Docket Number:	19-BSTD-03
Project Title:	2022 Energy Code Pre-Rulemaking
TN #:	236371
Document Title:	HVI Comments on 2022 Energy Code Pre-Rulemaking
Description:	N/A
Filer:	Patty Paul
Organization:	Home Ventilating Institute (HVI)
Submitter Role:	Public
Submission Date:	1/20/2021 1:33:01 PM
Docketed Date:	1/20/2021

Re: Docket No. 19-BSTD-03, 2022 Energy Code Pre-Rulemaking; *Response to TN 236201*

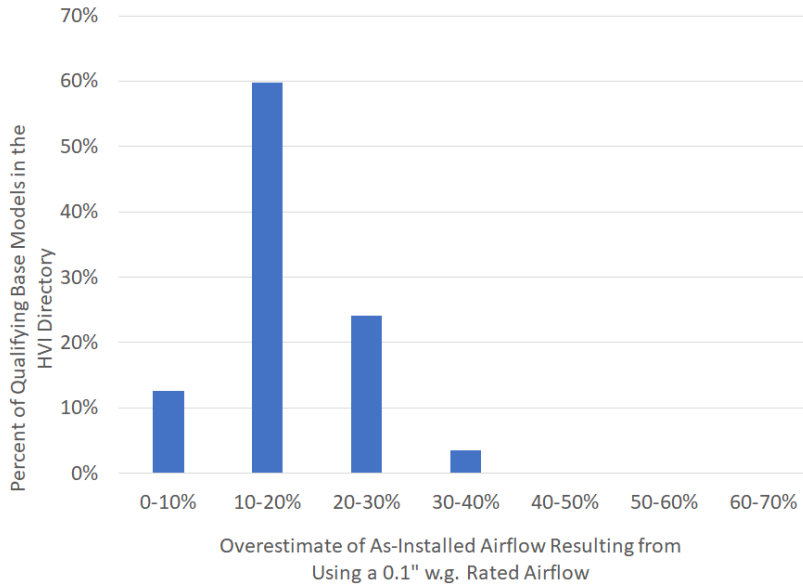
CASE's memo reported the number of manufacturers with kitchen exhaust models that were found to be compliant with proposed targets of 250 and 280 cfm at 0.1 in. w.g. However, it is important to note that LBNL's recommended airflow targets when used as a proxy for CE are "as-installed" airflow targets, not airflow at 0.1 in. w.g.⁴ Referencing a rated airflow at 0.1 in. w.g. can significantly overestimate "as-installed" airflow, as shown by Figure 1 below.

To provide a better estimate of "as-installed" airflow, HVI has developed the metric "Nominal Installed Airflow" (NIA) within HVI Publication 920; this metric accounts for the pressure drop and reduction in airflow that are associated with a typical duct installation (i.e., up to 10' of duct, 2 elbows, and one termination fitting). HVI recommends that NIA be used any time Title-24 intends to reference an "as-installed" airflow.

Figure 2. Calculated NIA (preliminary data) as a function of tested airflow at 0.1 in. w.g.

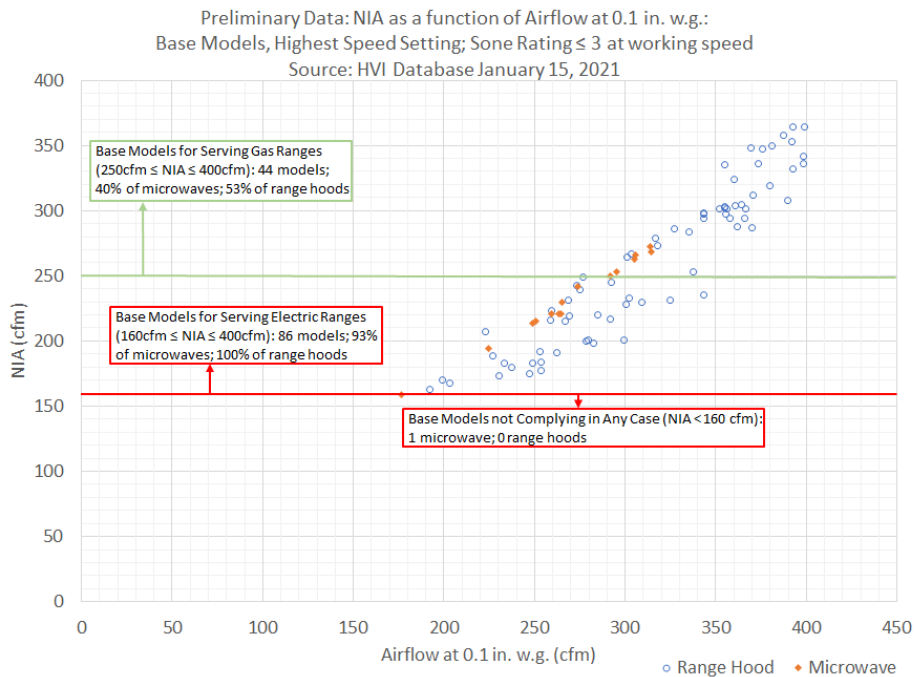
If CEC were to reference an NIA instead of airflow at 0.1 in. w.g. (and maintain Title 24-2019's same rating requirement), HVI's analysis shows that there are still a significant number of compliant base models with an airflow ≤ 400 cfm that exist today. Figure 2, based on HVI's preliminary calculations of NIA for base models in HVI's database as of January 15, 2021, shows that only 1 model is not likely to achieve a minimum as-installed airflow of 160 cfm (i.e., the as-installed airflow that HVI recommends CEC adopt for kitchen exhaust serving electric cooking appliances). The percent of models that are likely to achieve an as-installed airflow of at least 160 cfm are 93% of microwaves and 100% of range hoods. If CEC were to set the bar for kitchen exhaust serving gas cooking appliances at an as-installed airflow of 250 cfm, 44 base models would likely reach this target, representing 40% of microwaves and 53% of range hoods. Note that each base model in HVI's database may represent several derived models that are available from one or more brand owners. HVI intends to publish final NIA values no later than Q2 2021: well in advance of the effective date for Title 24-2022.
